Range SA Large Regional - Ho.Re.Ca.	Model 9100 – 95 – Krea Touch	N° T.I. XX_2024
Serial Number See page 2 / 2	Subject <b>NEW PISTON ASSEMBLY Z4000 ES/FB</b>

**Pre - modification upper piston ass.**

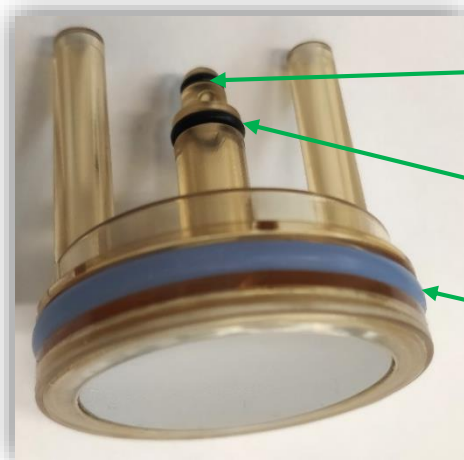
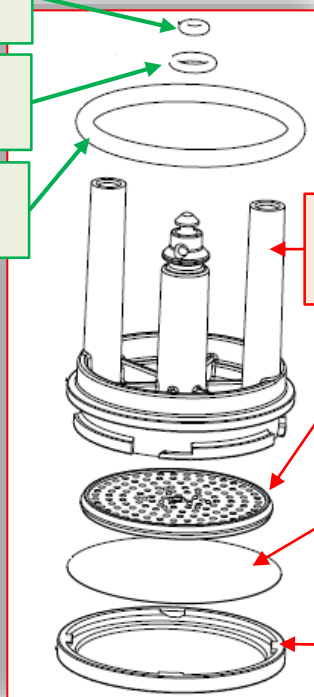
**Pre – modified ES/FB Z4000 upper piston** assembly has been replaced by **new "ESFB Z4000 welded piston assembly + three O-Rings"**.

For the **new upper piston** assembly the filter is welded to the piston.

This ensures that the filter lasts for a greater number of strokes.

**New ESFB Z4000 welded piston assembly + three O-Rings**  
Spare code: **266009**

The **three O-Rings 1, 2, 3** can be ordered individually

- it's possible to use a **new** ESFB Z4000 *welded piston assembly* + **three O-Rings (266009)** replacing a **pre - modification upper piston** assembly.
- Codes **260204**, **256753**, **256737**, **256754** can be ordered separately while supplies last.
